Westinghouse Electric Company
Hematite Facility
3300 State Road P
Festus MO 63028
U.S.A.

Attachment: WEC Hematite Environmental Monitoring Plan (PO-EM-001, Rev. 1)

Subject: Response to NRC Request for Additional Information (TAC No. L52641)

NRC RAIs regarding EMP Revision 0 and Westinghouse responses with references to EMP Revision 1 (attachment):

Figure 5-3 Air Flow Direction Vector Histogram

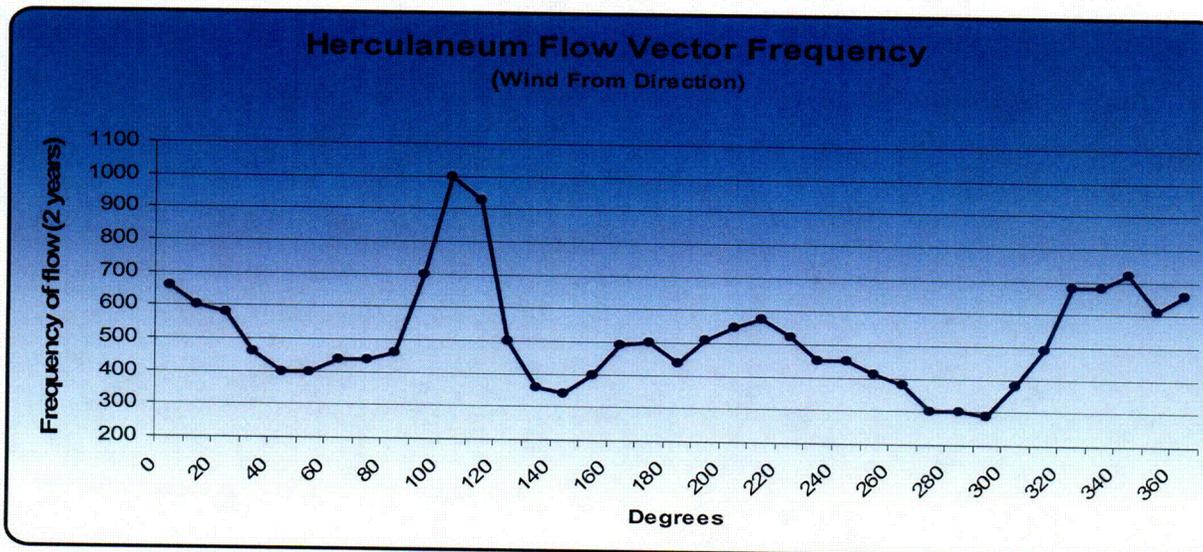
18. *Page 6-12, last paragraph: Reference the source of the predominant wind direction. Explain why the words "should be" are used versus "will be."*

This paragraph has been revised because the fourth air sampler has been established. Both sets of wind data in the EMP show that one of the more predominant wind directions is to the northwest.

Figure 6-3 Air and Soil and Vegetation Sample Locations

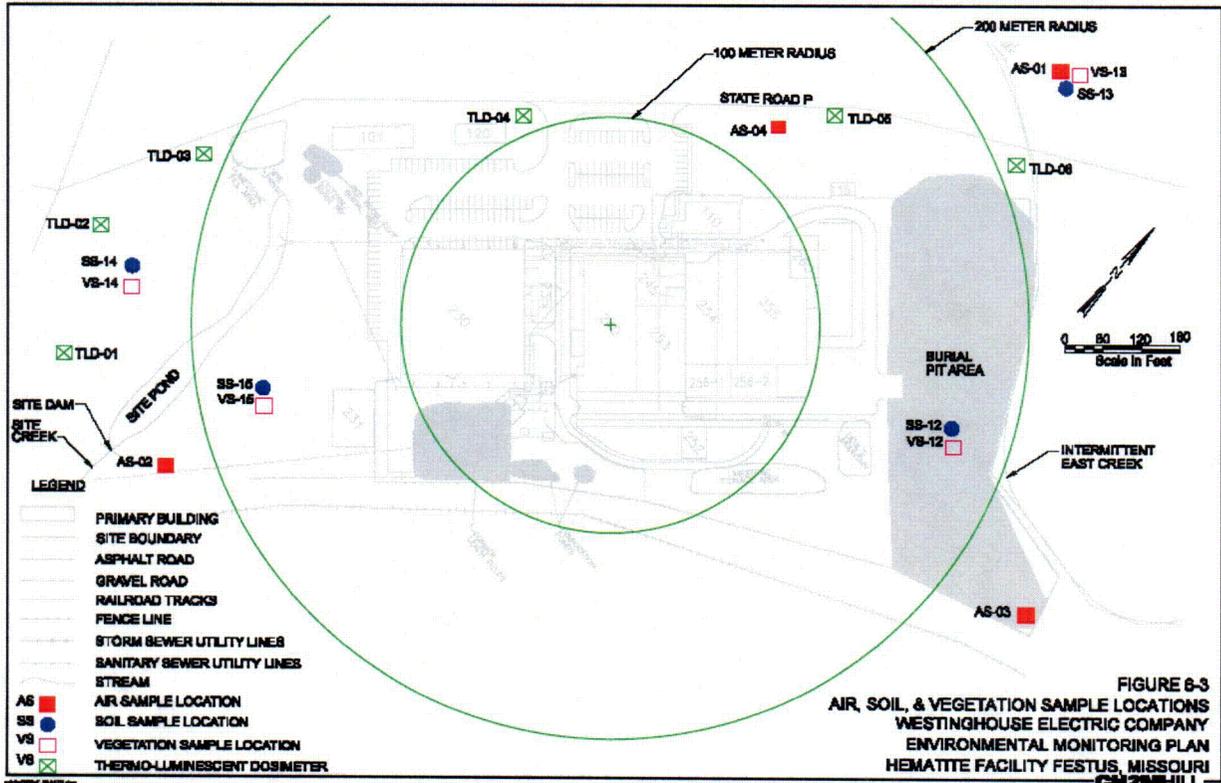
15. *Page 6-11: Provide justification for placement of the Hematite site perimeter air samplers. An acceptable methodology would consider such factors as the site's prevailing wind direction, and the distance to local population centers.*

16. *Page 6-11 and page 6-12: Justify the applicability of regional meteorological data to the Hematite site with due consideration of local terrain effects, and then justify the correct placement of the perimeter air samplers.*

The EMP references two sets of meteorological data that contradict each other. Due to the lack of on site data and the contradiction of the other data, section 5.3.1, EMP rev. 1, last sentence states, "Based on the directional variability, the sampling program has been designed to provide 360 degree coverage around the main plant areas." Four permanent samplers are set up at the site boundary. Two more perimeter samplers and additional temporary work control samplers will be used during building demolition and soil remediation. The location of these temporary work control samplers will change according to daily wind direction and operations. Significant changes in the wind direction during the day will also change the location of the temporary air samplers.

Figure 6-7 Site Dam and Composite Collection System Diagram 20

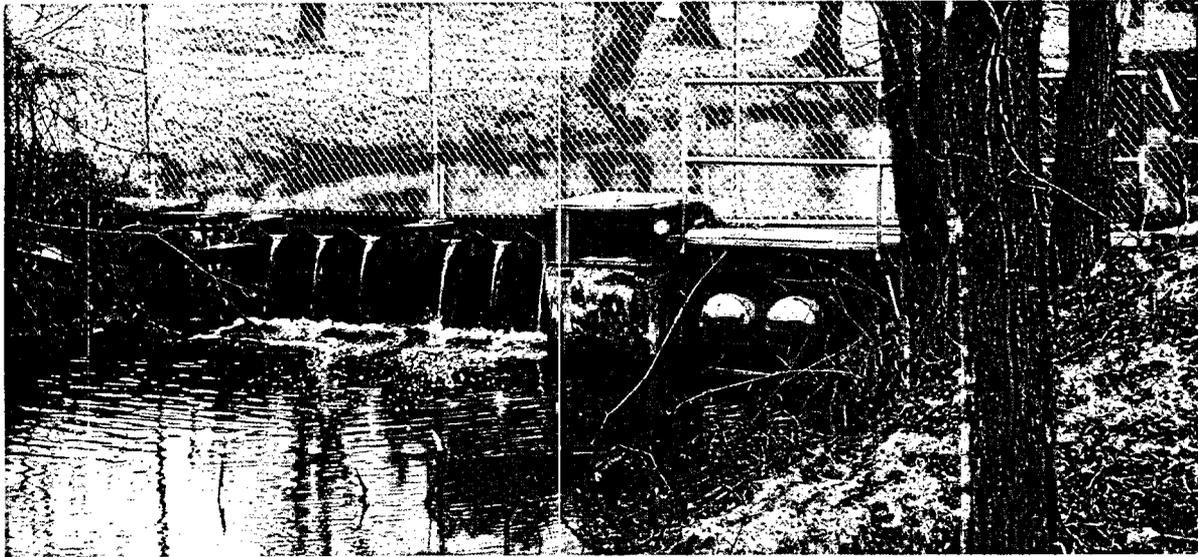
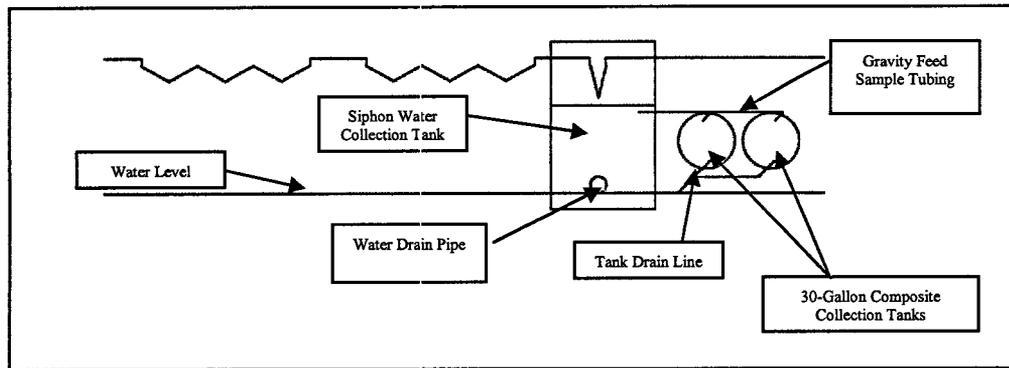
27. *Page 6-21, Section 6.4.3: Weir Sampling. Please show in a separate figure, or sketch the relative locations of, the siphon tank, the small 30 V-notch weir feeding the siphon tank, the siphon tank and the site dam with its six (6) 120 V-notch weirs. The figure or sketch may start from an upstream point and end at a downstream point of the system. Also, please explain the function of the two 30-gallon composite collection drums and their relationships to the weirs and the siphon tank system. The water flow system information is not clear from the descriptions.*

Westinghouse has included a diagram for the composite collection drums. The purpose of the drums is to collect a small fraction of the water in the siphon tank to make a composite sample over a one week period. Please refer to the EMP, Rev. 1, section 6.4.3, for this RAI.
